**2013 Bond Program
Series 2, Bid Package #18**

**Barnard ES, Bemis ES, Wass ES, Boulan MS, Larson MS, and
Administrative Building MEP Upgrades
IAE Kitchen Upgrades
Athens High & Troy High Door Replacements**

PROJECT MANUAL

ALTERNATE E1 - DDC INPUT FROM OCCUPANCY SENSORS WIRING & CONTROL

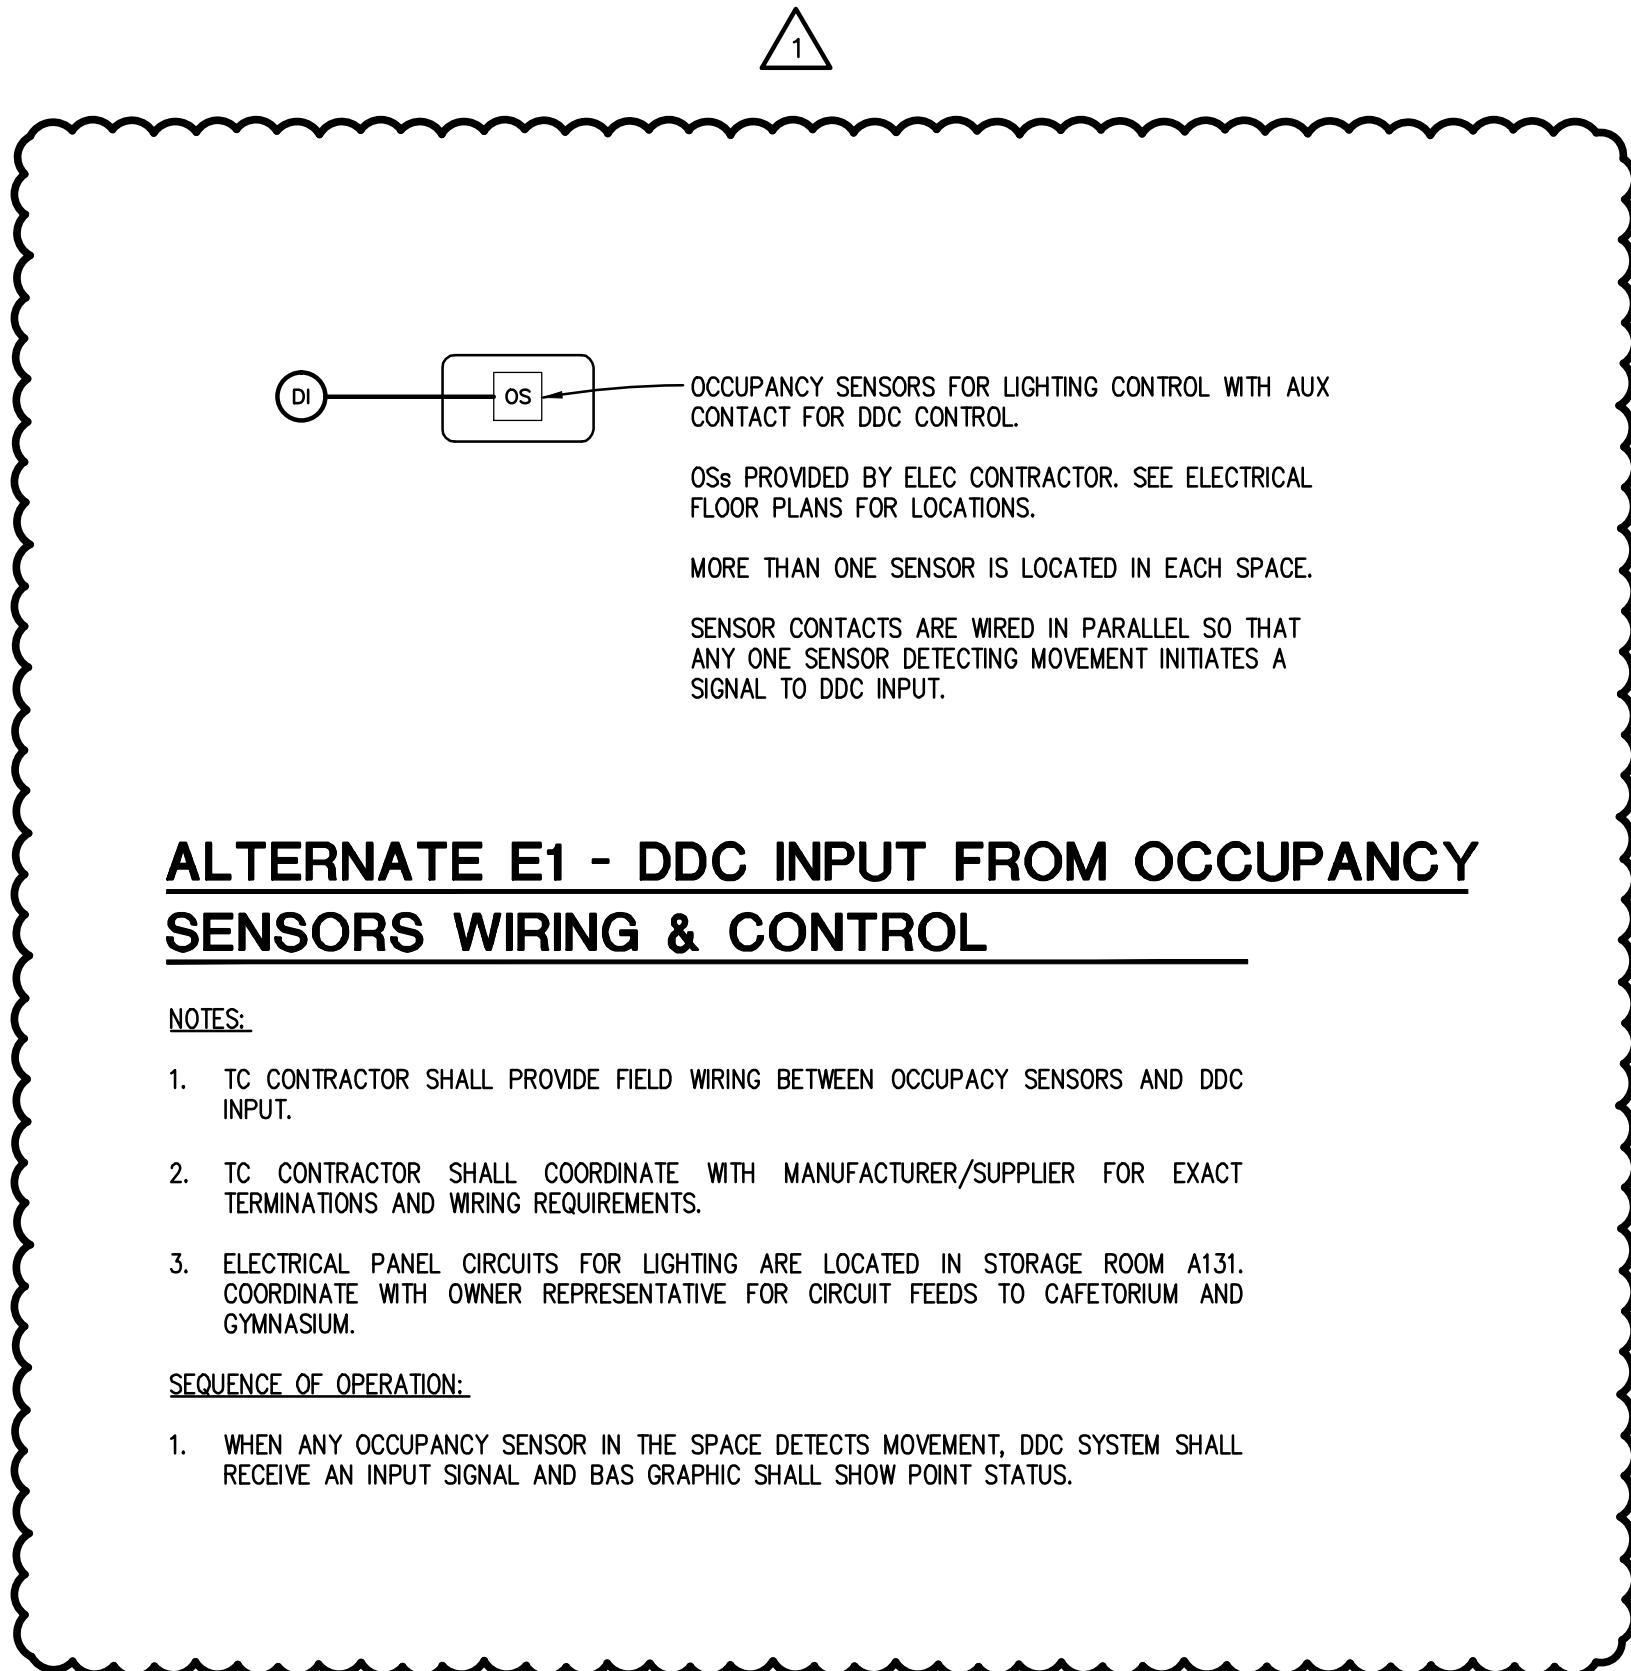
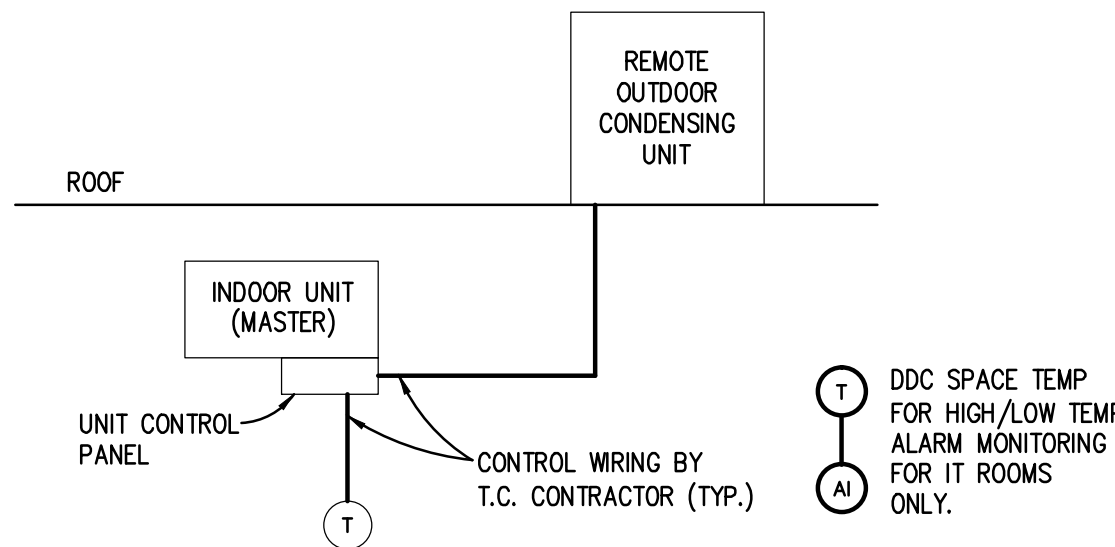
- MD-1 Refer to Drawing No. M3.1A (not reissued):
- A. Added the following to Construction Key Note 2: "Connect pumped condensate drain to existing condensate piping above ceiling."
- MD-2 Refer to Drawing No. M5.1 (not reissued):
- A. Removed DTE Prescription Note.
- MD-3 Refer to Drawing No. M7.3 (not reissued):
- A. Added Note 6 to Water Source Heat Pump Schedule to read: "Provide with condensate pump."
- MD-4 Refer to Drawing No. M8.3 (reissued):
- A. Added TC detail for occupancy sensor(s) tie-in to DDC for Alternate E-1.

ALTERNATE E1 - DDC INPUT FROM OCCUPANCY SENSORS WIRING & CONTROL

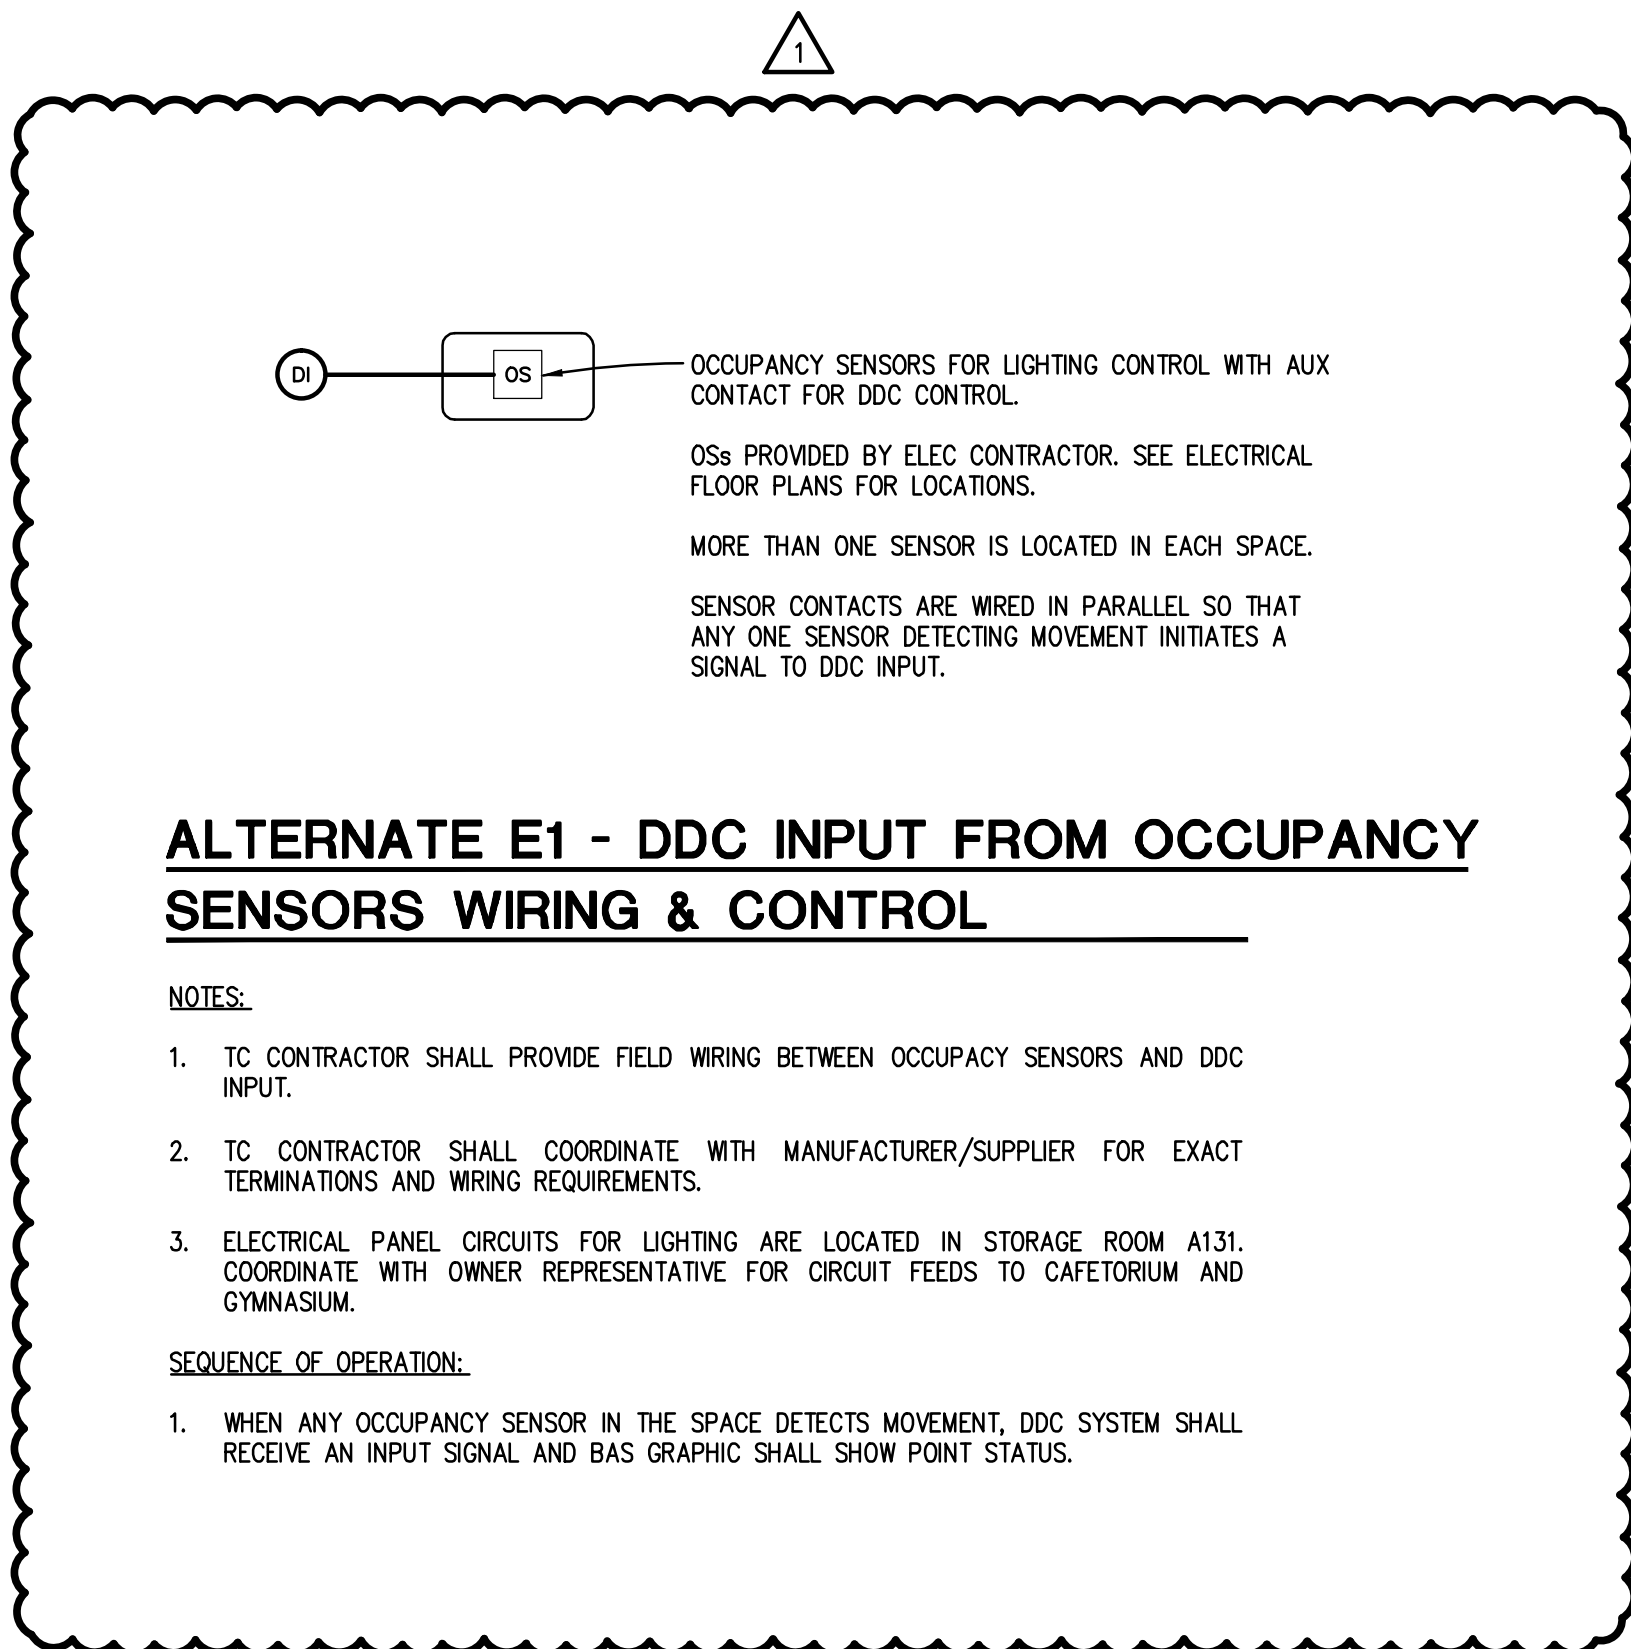
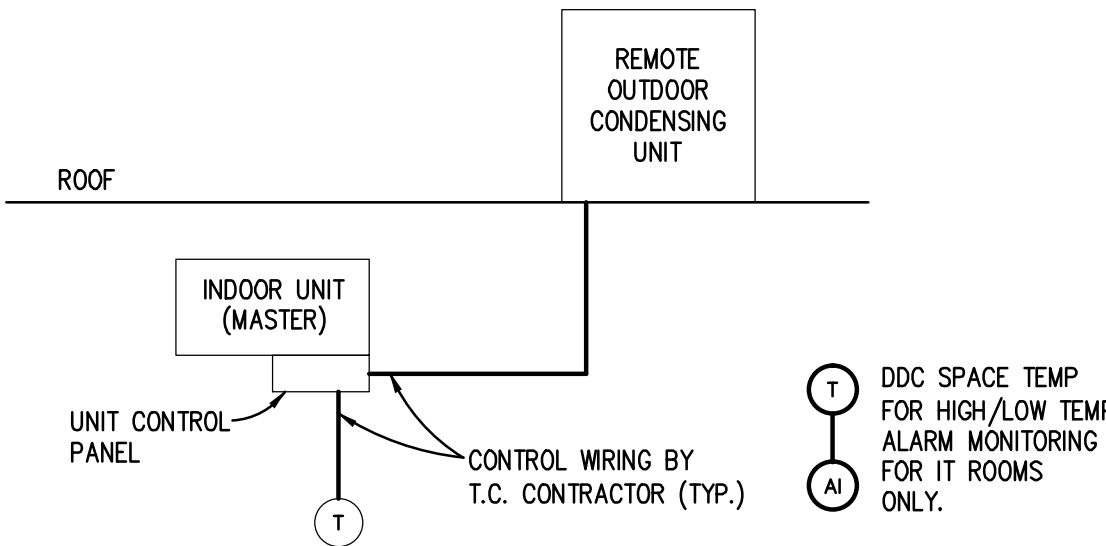
MD-12 Refer to Drawing No. M8.3 (reissued):
